Access Compliance Report

Public Rights-of-Way

Intersection ID: 10033475	Main Street: OLD_PINEVILLE_RD	Cross Street: N/A	Location: SE
ADA ID: A478B4D5567D	Ramp Type: PerpDiag	Initial Pass/Fail: Fail	Overall Compliance: No
		Severity Score: 10

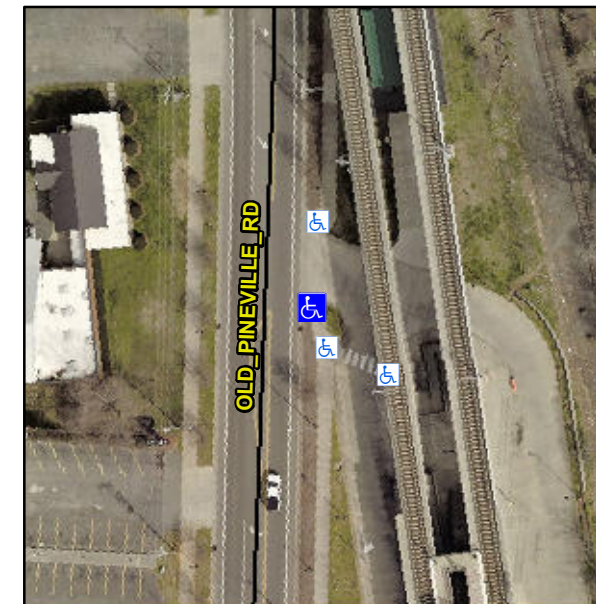
Not Found, R304.5.1, R304.5.3

Compliance	Description	Data	Compliance	Description	Data
N/A	Ramp Length (in)	89.0	Yes	Ramp Slope (%)	5.2
No	Ramp Width (in)	47.0	No	Ramp XSlope (%)	2.3
N/A	Flare Type LT	N/A	N/A	Flare Type RT	N/A
N/A	Flare Slope LT (%)	N/A	N/A	Flare Slope RT (%)	N/A
N/A	Flare Traversable LT?	N/A	N/A	Flare Traversable RT?	N/A
N/A	Landing Length (in)	N/A	N/A	DWS Provided?	N/A
N/A	Landing Width (in)	N/A	N/A	DWS Contrast?	N/A
N/A	Landing Slope (%)	N/A	N/A	DWS Length (in)	N/A
N/A	Landing X Slope (%)	N/A	N/A	DWS Full Width?	N/A
N/A	Landing Curb? (Y/N)	N/A	N/A	DWS Offset (in)	N/A
N/A	Shared Landing?	N/A			
N/A	Gutter Ponding?	N/A	N/A	Gutter Slope (%)	N/A
N/A	Gutter Lip Ht (in)	N/A	N/A	Gutter X Slope (%)	N/A
N/A	Painted X Walk1?	No	N/A	Painted X Walk2?	No
	X Walk 1 Direction	To N		X Walk 2 Direction	To W
N/A	X Walk 1 Width (in)	N/A	N/A	X Walk 2 Width (in)	N/A
	X Walk 1 Slope (%)	2.0		X Walk 2 Slope (%)	1.3
	X Walk 1 X Slope (%)	2.3		X Walk 2 X Slope (%)	0.9

Remove & Replace Curb Ramp With Two New Directional Ramps or Equivalent.
